*Application for Amendment of USNRC Source Materials
License SUA-1601,
Ross ISR Project, Kendrick Expansion Area*

*RAI Question and Answer Responses for the
Kendrick Expansion Area Technical Report
Docket #40-09091*

Prepared by:
Strata Energy, Inc.
2929 New Haven Road
Oshoto, WY 82721

November 2016

Figure TR RAI 5.7.8-2-1. Potential Operational Surface Water Monitoring Network.

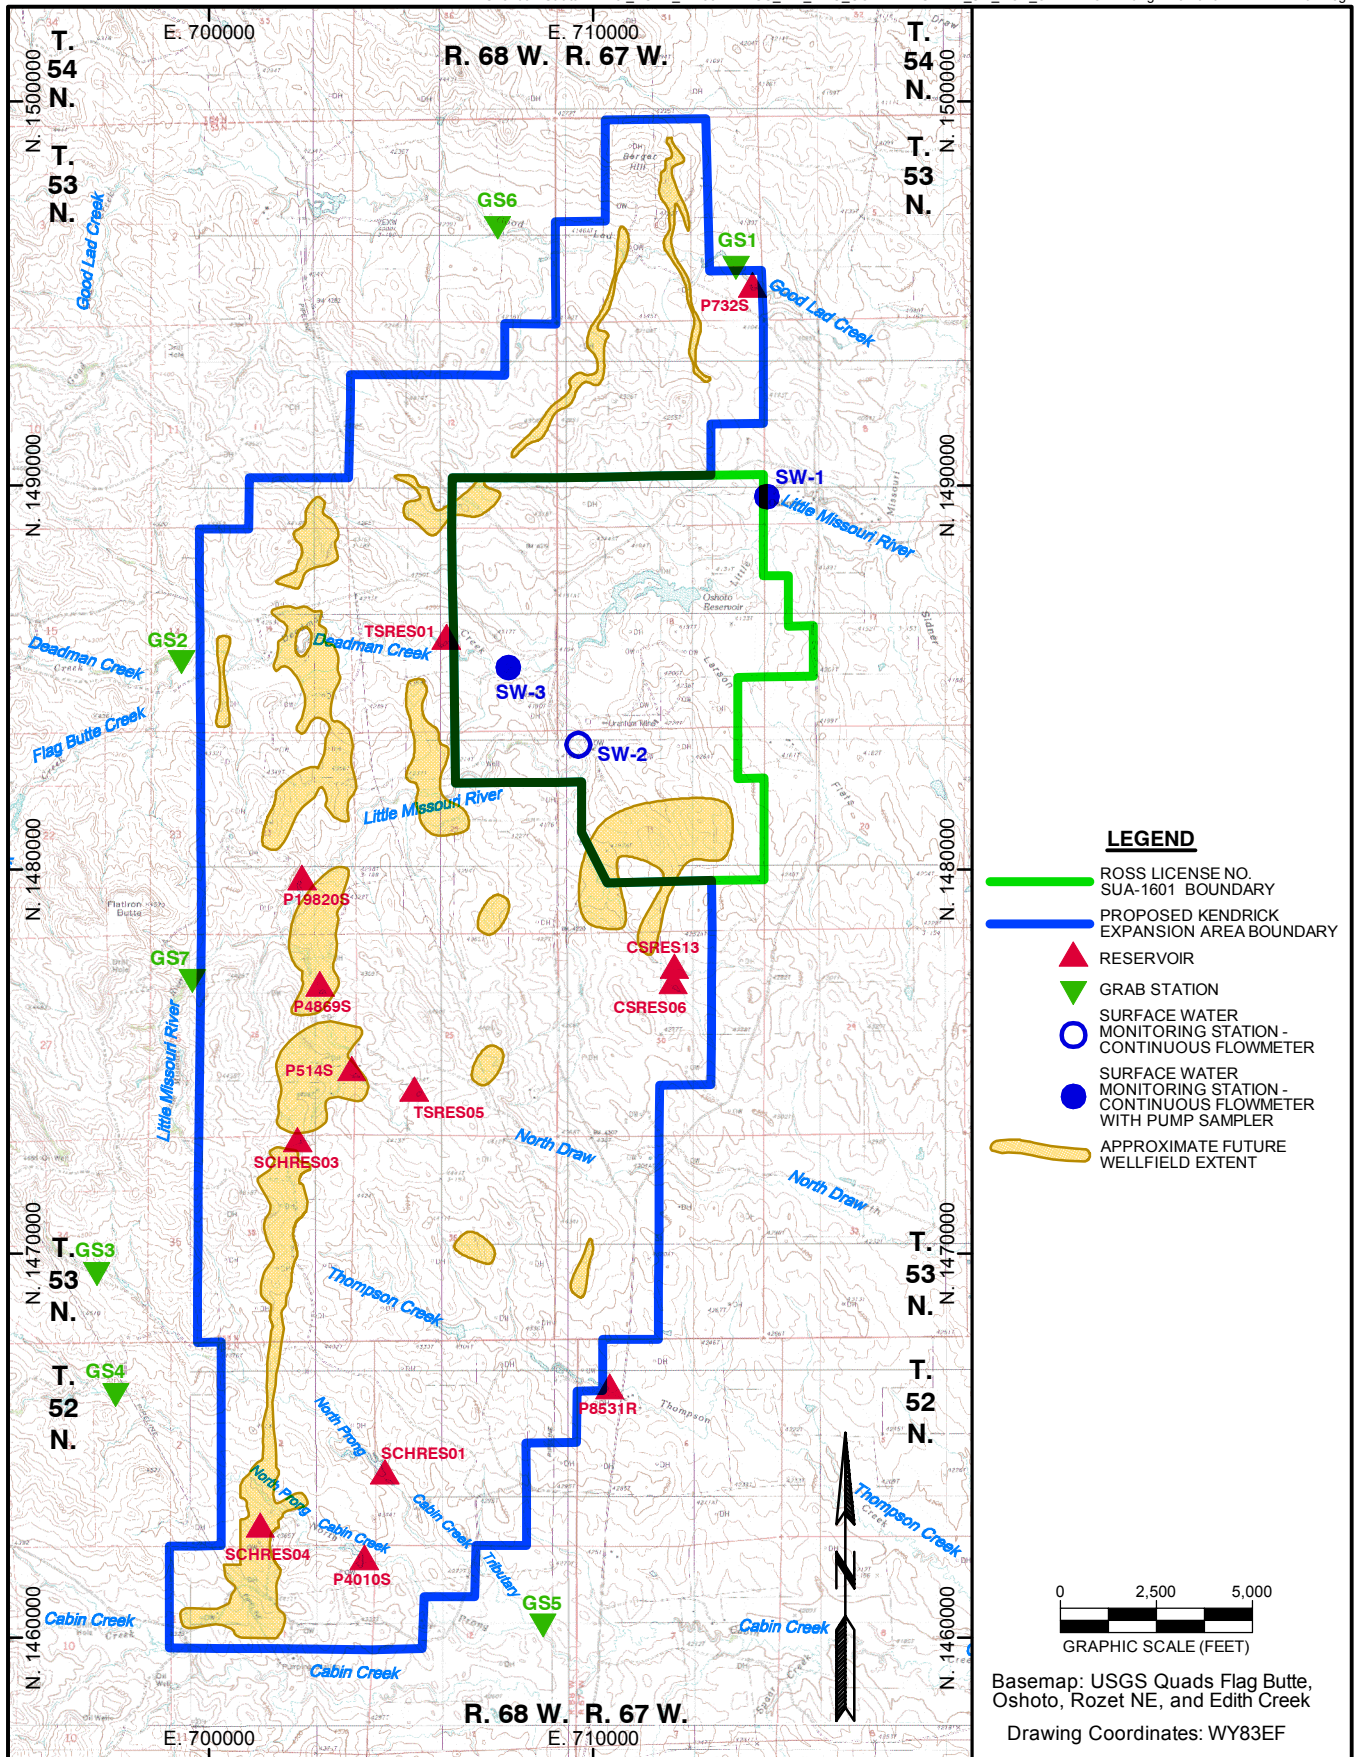
In Section 5.7.8.2 and on Figure 5.7-1 of the Kendrick TR, Strata discusses “potential” surface water sampling locations based on an evaluation in the wellfield data package for a specific mine unit. The potential locations include 3 monitoring stations, 6 grab stations and 13 reservoirs. In Section 2.7 of the Kendrick TR, Table 2.7-11 lists 19 reservoirs of which 18 are located within the proposed Kendrick area and the preoperational sampling conducted at four surface water sampling locations (Table 2.7-14), four grab stations and 18 reservoirs. The information provided in the application is insufficient in detail for staff to evaluate whether or not it meets the above review procedures, acceptance criterion or guidance or that the justification for departure from the guidance was adequate.

Reservoir TSRES03 would not be representative of the water quality upstream of the site during operation since proposed wellfields are located directly upstream and uphill of the reservoir. In order to satisfy the requirement for an upstream sample location on the Little Missouri River, Strata proposes to add an additional grab station location just outside the KEA boundary on the Little Missouri River. The new grab station location (GS7) is shown on Figure TR RAI 5.7.8-1-1 along with the other operational surface water monitoring sites as previously depicted on KEA TR Figure 5.7.8-1. KEA TR Figure 5.7.8-1 will be replaced following acceptance of this response by NRC staff.

In a Category 1 public meeting held on October 4, 2016 (ML16265A542) to discuss NRC RAIs, NRC staff noted that there is a discrepancy between KEA TR Figure 2.7-8 and KEA ER Figure 6.1-1 with respect to the location of monitoring site GS2. The location of GS2 in KEA TR Figure 2.7-8, which was sampled during preoperational baseline, was located within the proposed KEA. Due to its location downstream of proposed wellfields the site was moved upstream and just outside the KEA boundary for operational surface water monitoring as shown on KEA ER Figure 6.1-1. The updated location meets the recommendations of RG 4.14.
